BP'S RESPONSE TO ORSTED'S DEADLINE 1 SUBMISSIONS

Deadline 2 submission**BP'S RESPONSE TO ORSTED'S DEADLINE 1 SUBMISSIONS**

Figure 8 from bp's Deadline 1 submission:

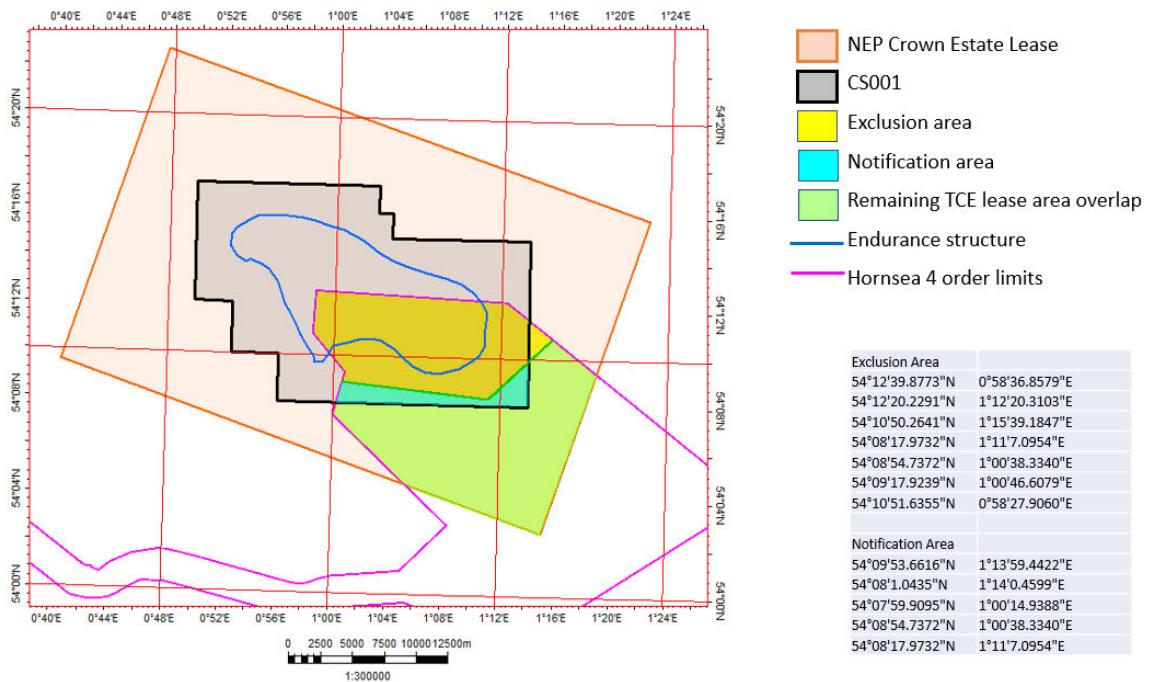
4.4 As can be seen from Figure 8, the Exclusion area represents a sub-part of the wider Overlap Zone (with the residual area shown in green). Under bp's proposed solution, Orsted are free to develop in the residual part of the Overlap Zone. For clarity, the Overlap Zone is the totality of the area over which the NEP project's Agreement for Lease area (shown shaded in orange in Figure 8) overlaps with the Hornsea 4 order limits (shown delineated in pink in Figure 8).

4.5 For the reasons set out in bp's Deadline 1 submission (and elaborated upon further in section 5 below), this mutual exclusivity is the only practical solution to enable both projects to come forward. The absence of a viable technical solution means it is not possible to otherwise mitigate their impacts upon one another.
